Project	IEEE 802.16 Broadband Wireless Access Working Group < http://ieee802.org/16 >	
Title	Fixes for Network Entry Flow Charts	
Date Submitted	2007-02-25	
Source(s)	Nadav Lavi et al Alvarion Ltd. [Address Line 1] [Address Line 2]	Voice: +97236457834 Fax: [Fax Number] [mailto:Nadav.lavi@alvarion.com]
Re:	IEEE Std 802.16-2004/Cor2/D2	
Abstract	Fixes for Network Entry Flow Charts in 802.16-2004/Cor2/D1	
Purpose	For the review in 802.16 Maint TG	
Notice	This document has been prepared to assist IEEE 802.16. It is offered as a basis for discussion and is not binding on the contributing individual(s) or organization(s). The material in this document is subject to change in form and content after further study. The contributor(s) reserve(s) the right to add, amend or withdraw material contained herein.	
Release	The contributor grants a free, irrevocable license to the IEEE to incorporate material contained in this contribution, and any modifications thereof, in the creation of an IEEE Standards publication; to copyright in the IEEE's name any IEEE Standards publication even though it may include portions of this contribution; and at the IEEE's sole discretion to permit others to reprodu

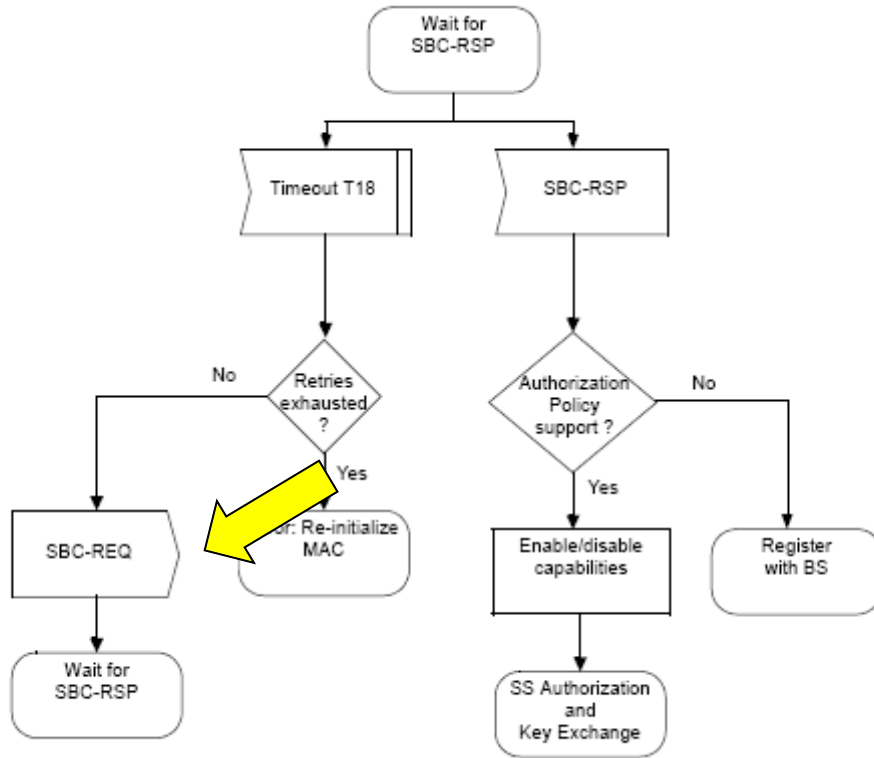
There is an unclear definition of how to handle expiration of T9 in the BS side in SBC transaction, and expiration of T17 in the BS side in REG transaction. The condition for “Release and age-out connections” is unclear and not well defined. In addition, this action is local to the BS and thus remains unknown to the SS. We suggest that the BS would send unsolicited RNG-RSP message with Abort instruction when these timers expire. The current Network Entry flow chart cannot handle retransmission, either due to processing delays or message drop. After the BS transmits a response message, it will proceed directly to the next state in the Network Entry flow and thus cannot handle a retransmission of request by the SS; this would cause the Network Entry procedure to end in failure. For example, the following flow chart (Figure 67 in 802.16e-2005) shows that BS sends SBC-RSP.

If the SS does not receive SBC-RSP within T18 timeout, it will retransmit the SBC-REQ (Figure 66).

Figure 70—Registration—BS

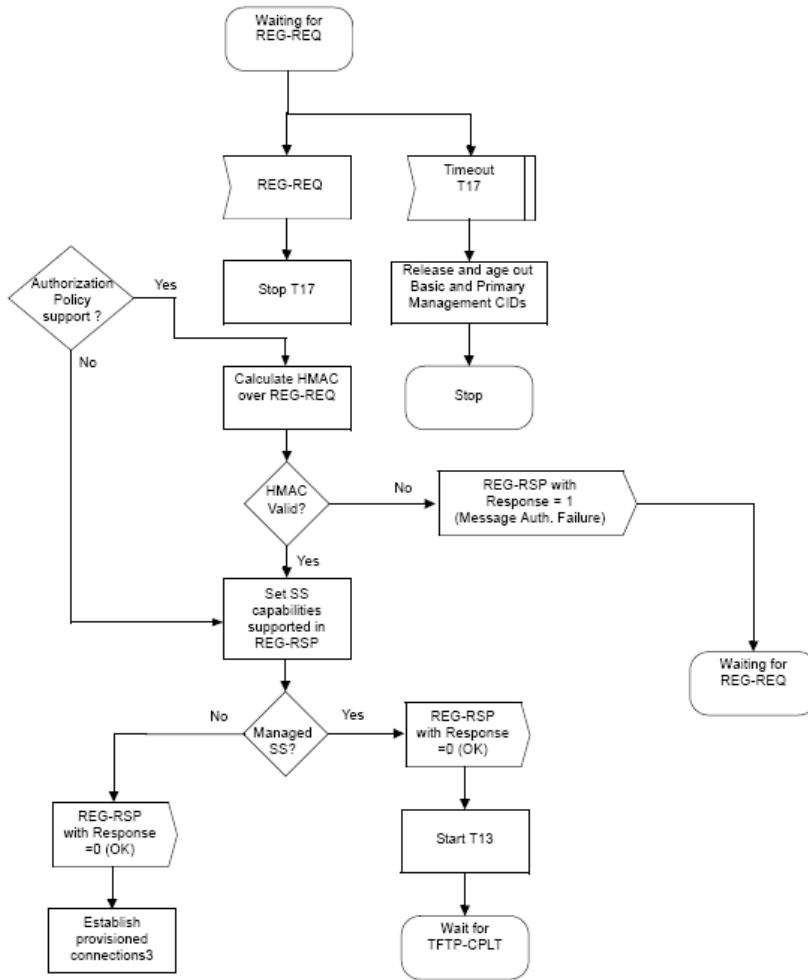
However after sending SBC-RSP, the BS proceeds directly to the registration step. The corresponding flow chart (Figure 70) does not contain any state where a retransmission of SBC-REQ can be received and processed. This is just an example of one single scenario. Similar failures can be identified for other steps in the entire Network Entry flow.

We suggest the Network Entry process be specified using 1) Network Entry state machine, and 2) set of actions/procedures of handling the Network Entry messages. This will provide a clearer definition of the network entry procedure as well as the handling of error/failure conditions.

Figure 67a-Handle SBC-REQ first reception, BS side.

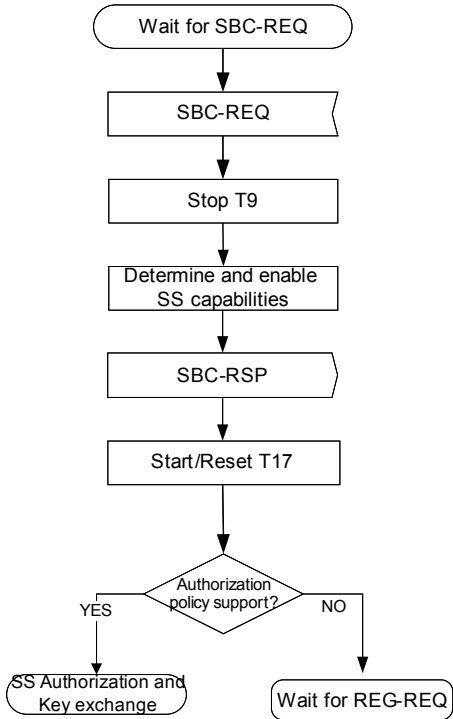
In 802.16-2004/Cor2/D2, replace Figure 67 in 6.3.9.7 with the following Figure 67a and 67b:

Figure 69 – Handle REG-RSP, SS side.

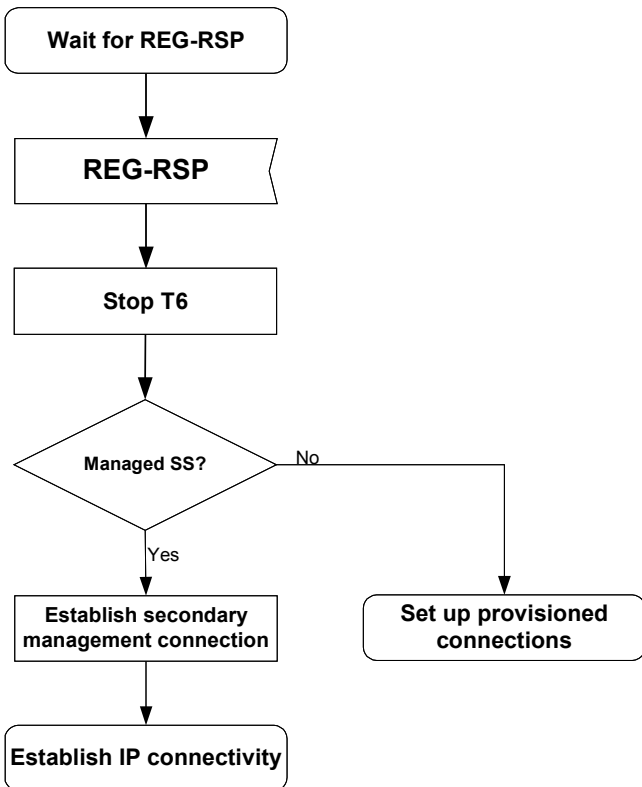
In 802.16-2004/Cor2/D2, replace Figure 69 in 6.3.9.9 with the following figure:

Figure 70a – Handle REG-REQ first reception (BS side).

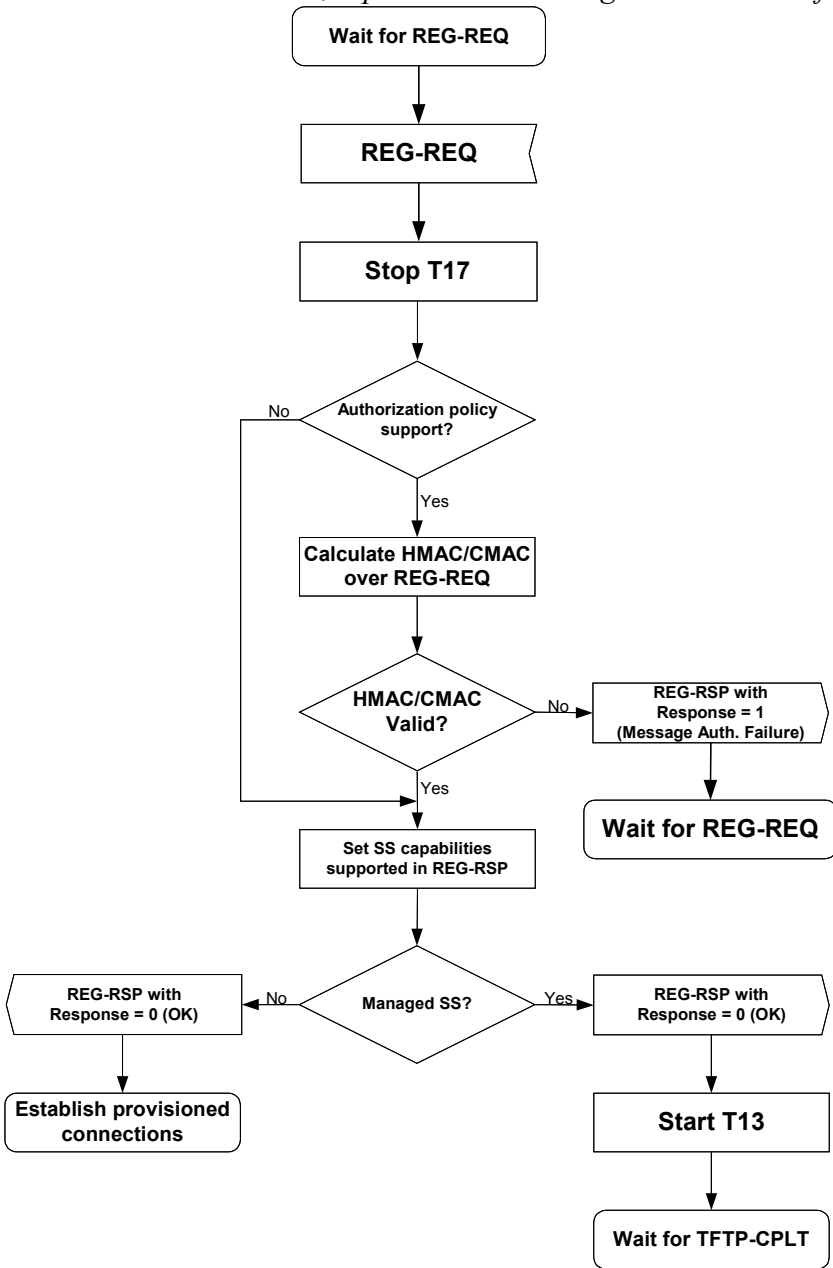
In 802.16-2004/Cor2/D2, replace in 6.3.9.9 Figure 70 with the following Figure 70a and Figure 70b:

Figure 66 – Handle SBC-RSP, SS side.

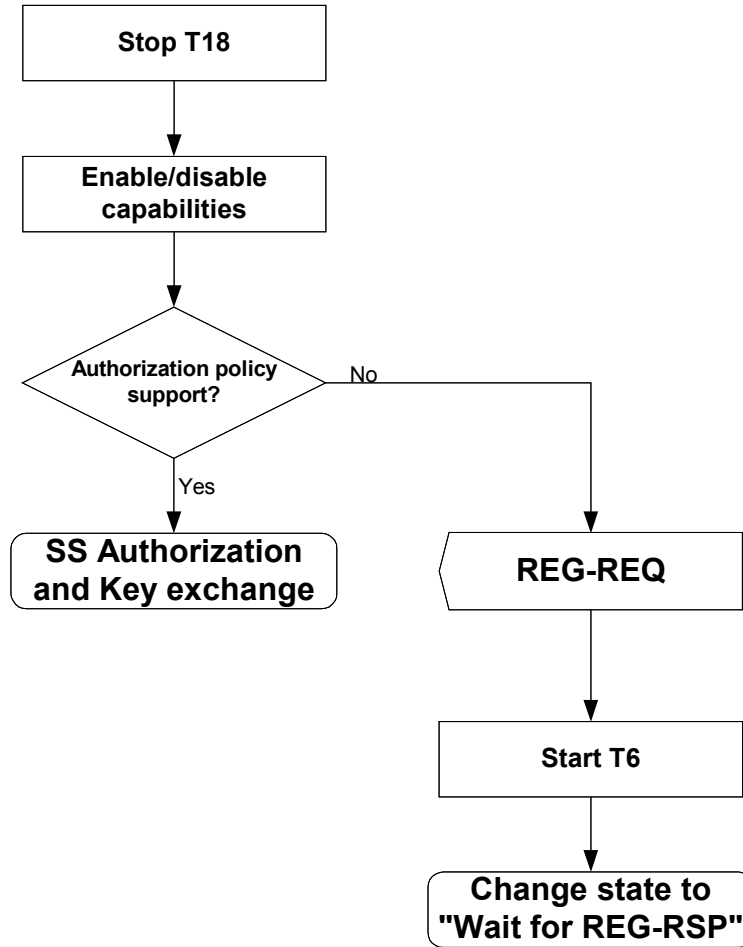
In 802.16-2004/Cor2/D2, Replace Figure 66 in 6.3.9.7 with the following figure:

Figure 87a – Handle CDMA Initial Ranging Code at BS

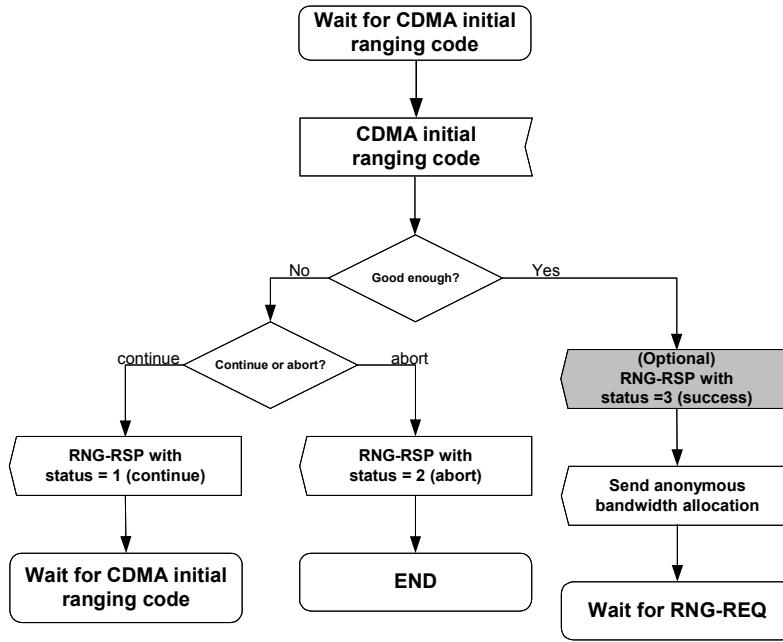
In 802.16-2004/Cor2/D2, replace Figure 87 with the following Figure 87a, Figure 87b and Figure 87c:

When the BS receives an initial-ranging CDMA code that requires no corrections ~~results in sending an RNG-RSP message with success status~~, the BS shall provide BW allocation for the SS using the CDMA_Allocation_IE to send an RNG-REQ message. Sending RNG-RSP message with status "Success" is optional.

Figure 70c – Network entry state-machine BS side

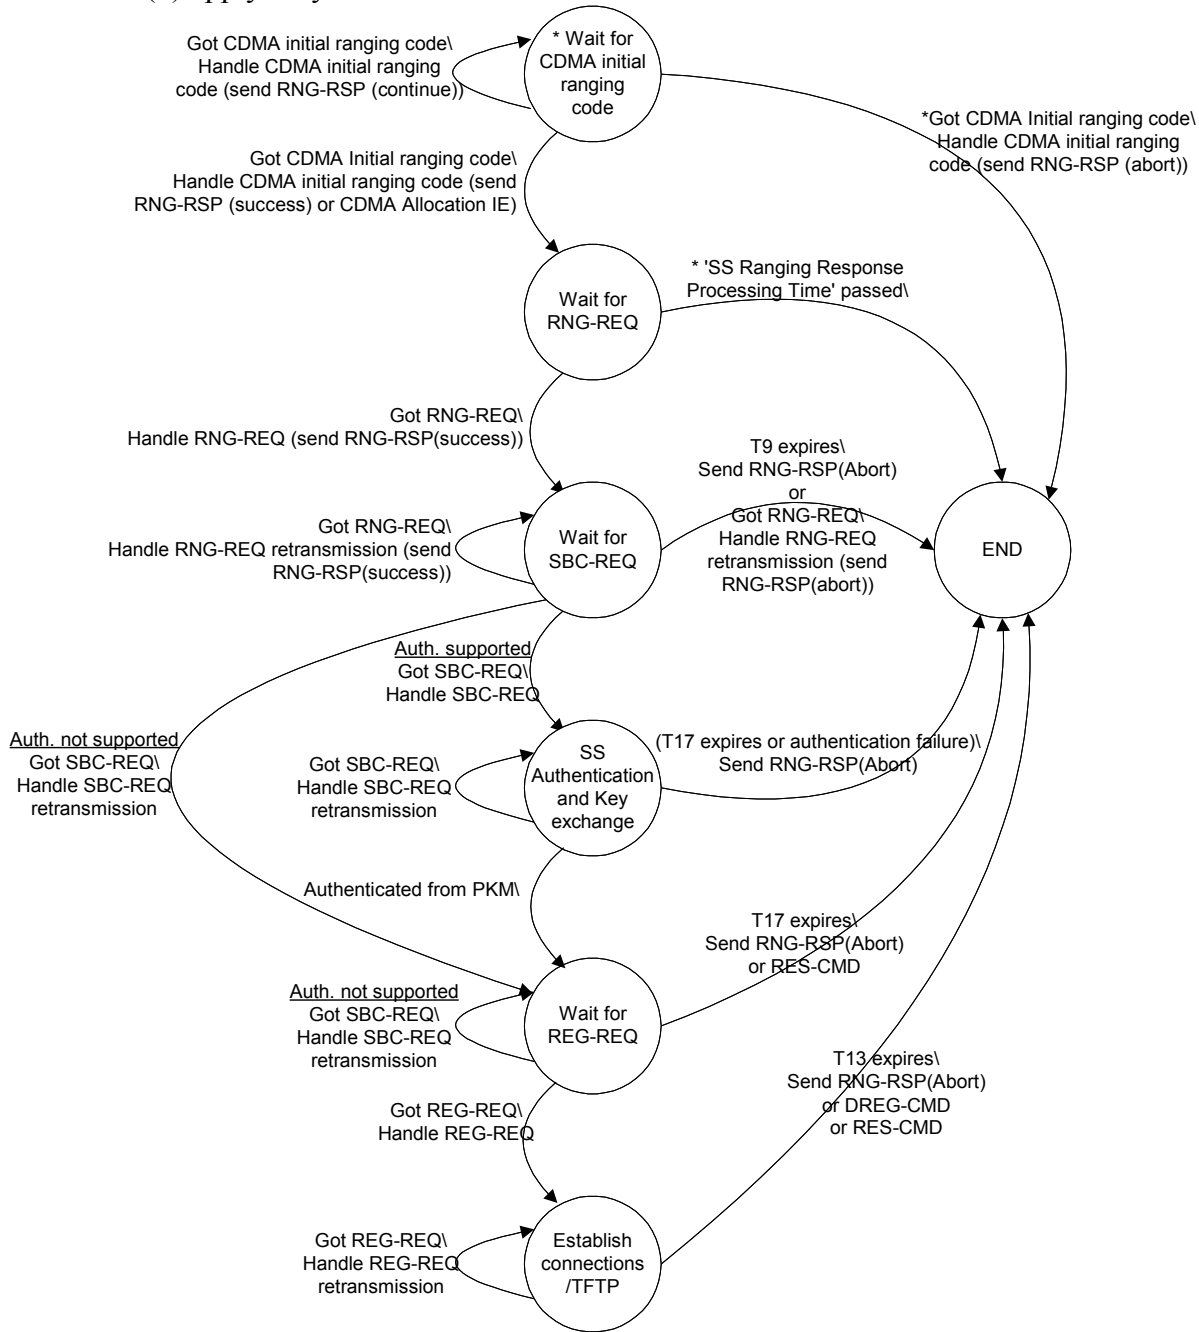
In 802.16-2004/Cor2/D2, add the following text at the end of Section 6.3.9.9, and change Figure 70a with the following Figure 70c:

The following Figure describes the NW entry process on BS side. The transitions and states that are marked with asterisks (*) apply only to OFDMA PHY.

Figure 70d – Network entry state-machine SS side

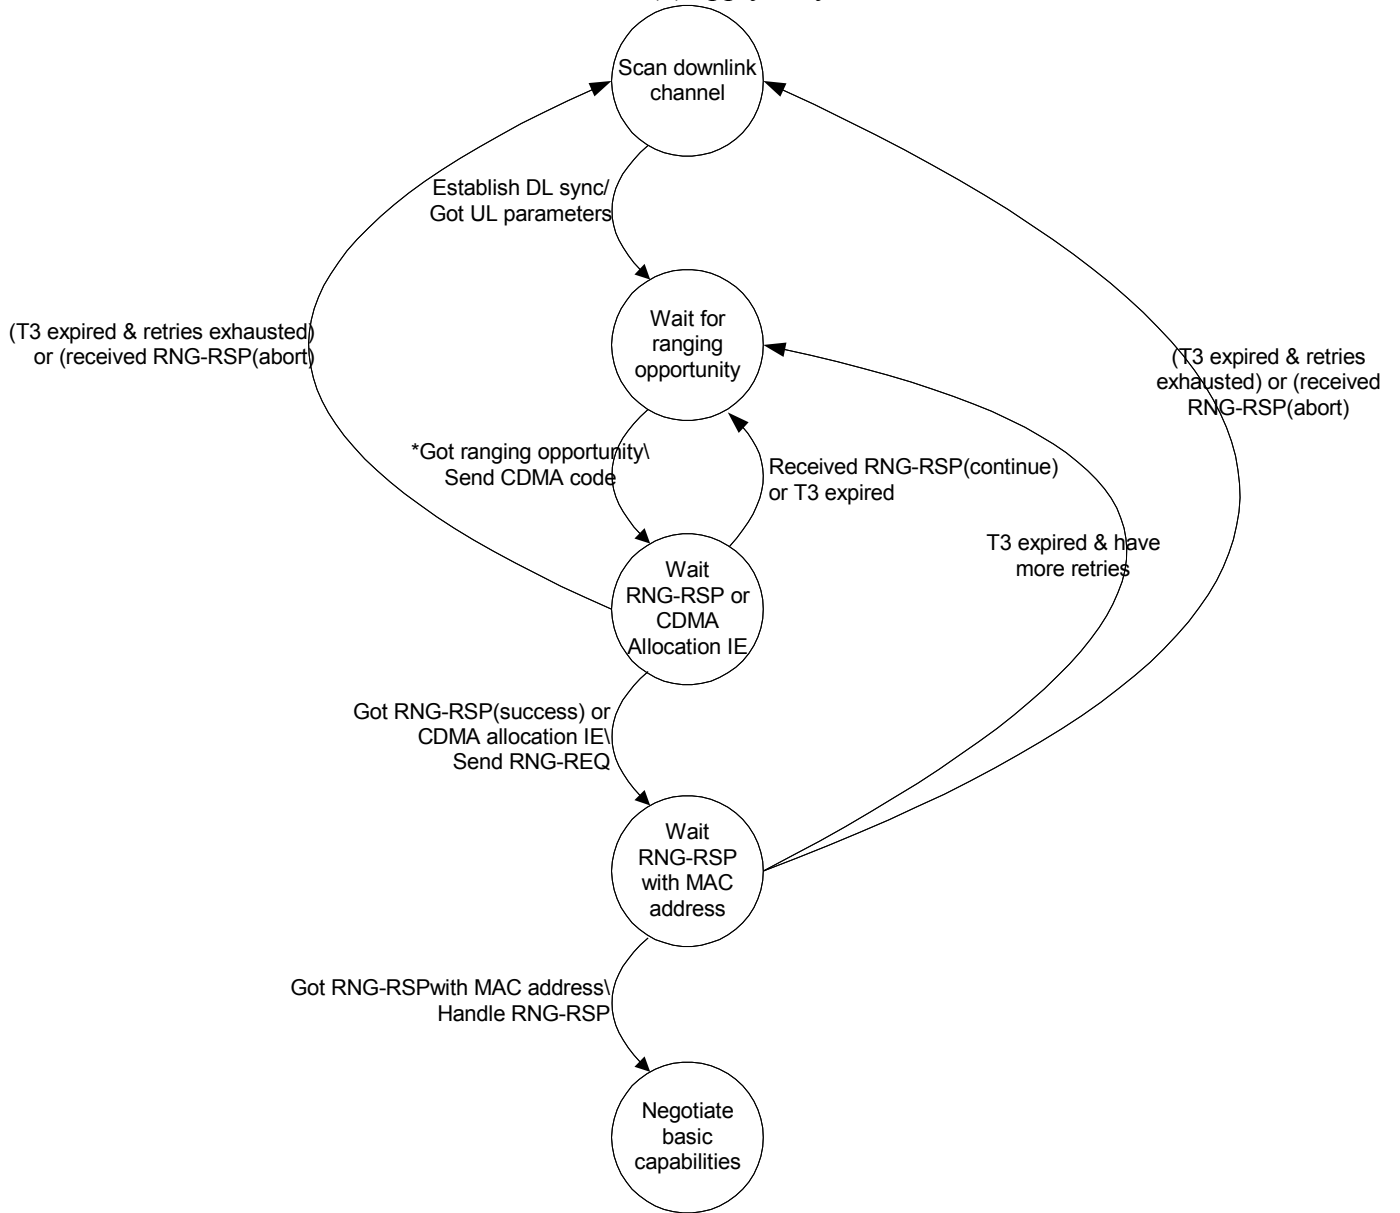
In 802.16-2004/Cor2/D2, add the following text at the end of Section 6.3.9.9, and change Figure 70b with the following Figures 70d:

The following Figure describes the Ranging procedure within the NW entry process on MS side. The transitions and states that are marked with asterisks (*) apply only to OFDMA PHY.

Figure 70e – Network entry state-machine SS side

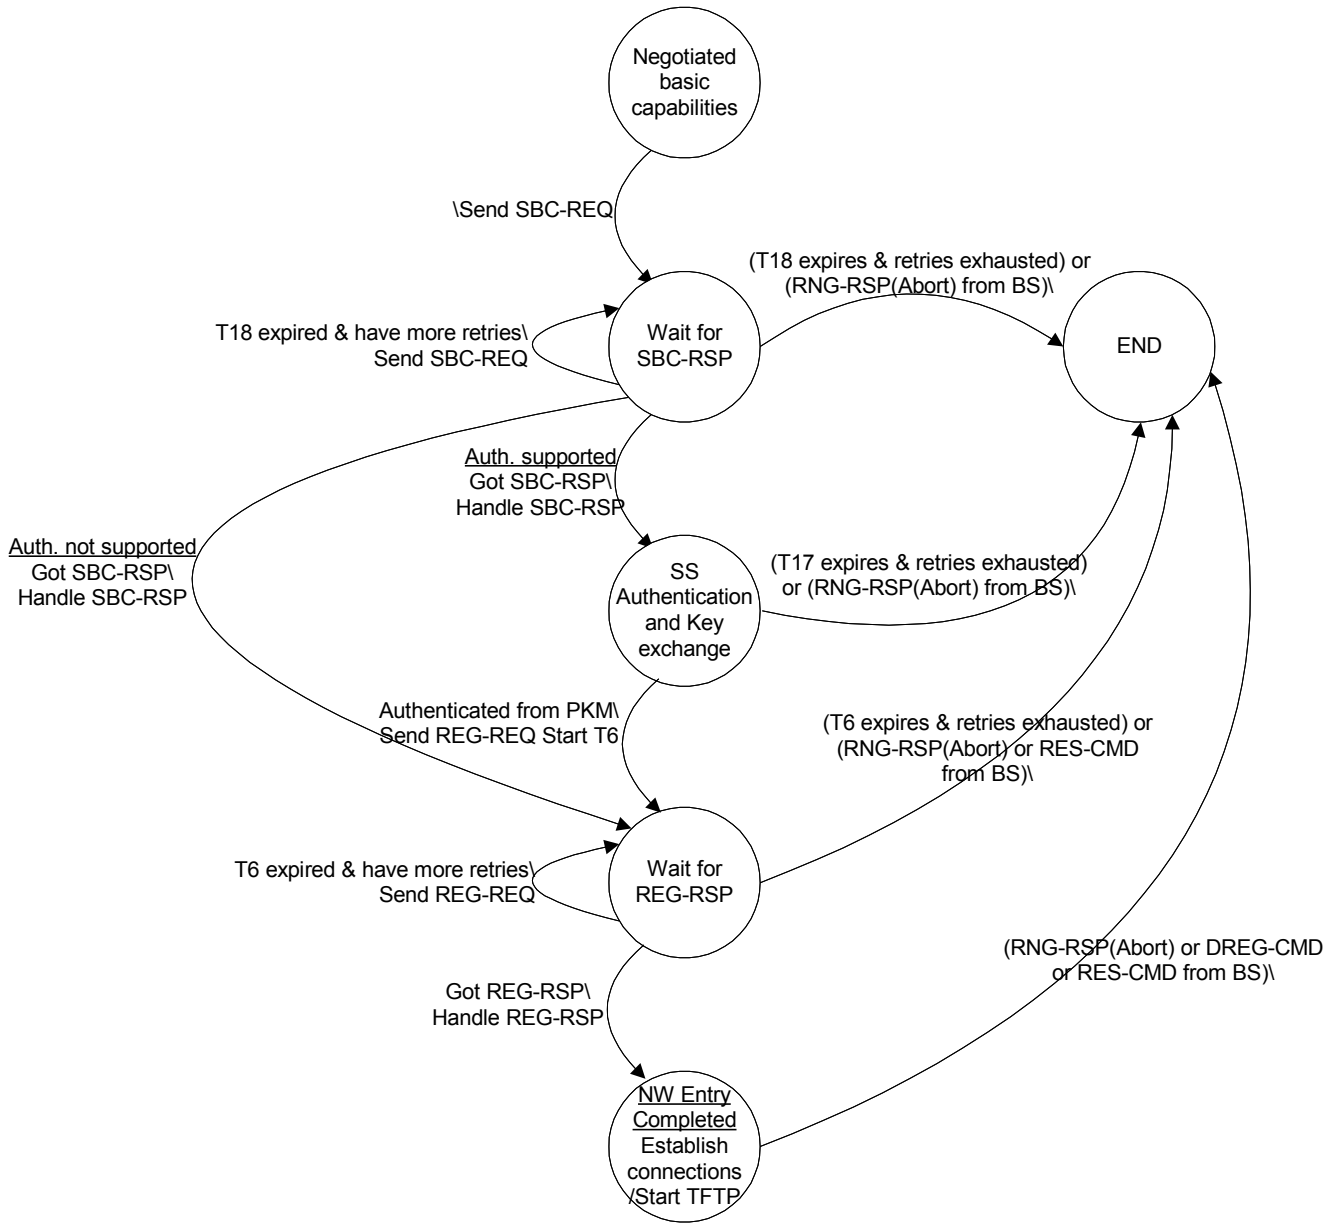
In 802.16-2004/Cor2/D2, add the following text at the end of Section 6.3.9.9, and add the following Figure 70e:

The following Figure describes the Ranging procedure within the NW entry process on MS side. The transitions and states that are marked with asterisks (*) apply only to OFDMA PHY.
